Service Advisory

W-122

Model: 53AA1A5L190 (ZT 1850 with 44" cutting deck)

Subject: 44 INCH DECK CHANGES

**710-1693 bolt and 748-3101 spacer****710-1852 bolt and 948-3020 spacer**

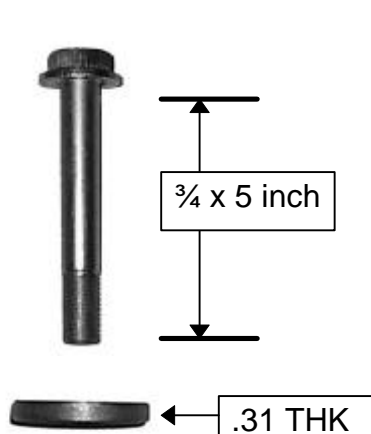
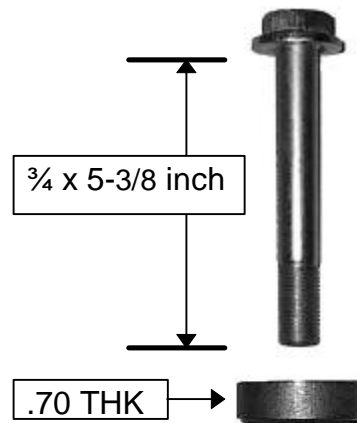
1. Two different sizes of spindle bolts and blade spacers can be used on the ZT 1850. The differences are in the length of the bolts and the thickness of the spacers. Refer to the pictures below.

When replacing these parts for service, part numbers 710-1693 bolt and 748-3101 spacer or 710-1852 bolt and 948-3020 spacer must be serviced together. Either length bolt can be used on the decks listed above as long as all three spindle assemblies use the same length bolt along with the correct spacer. Correct bolt and spacer combinations are shown below.

NOTE: A deck using the 5-3/8 inch bolt with the .70 inch thick spacer will cut approximately 3/8 inch lower than a deck using the 5 inch bolt with the .31 inch thick spacer.
